# SATARA WIND POWER PROJECT IN MAHARASHTRA, INDIA

Report ID	VKU.VER.174.23_VCS_1519
Project title	Satara Wind Power Project in Maharashtra, India
Project ID	VCS 1519
Verification period	01-January-2023 to 05-March-2024 (Inclusive of both dates)
Original date of issue	07-June-2024
Most recent date of issue	05-July-2024
Version	02

**Figure 05: Trends of PLF from 01-January-2023 to 05-March-2024**

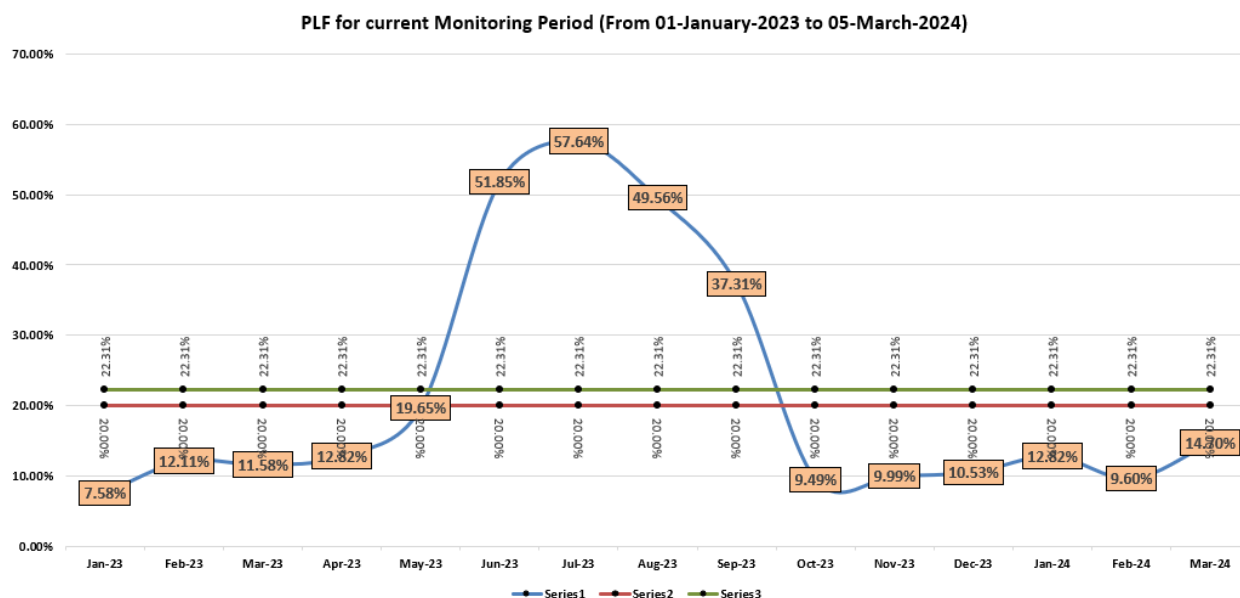
Based upon the Figure 05, it is clear that the monthly trend of PLF, till September-2023 is higher than the estimated and after September-2023 the trend of PLF is lower than the estimated. This is reflected in higher emission reductions for the current monitoring period at +11.56%. It is to
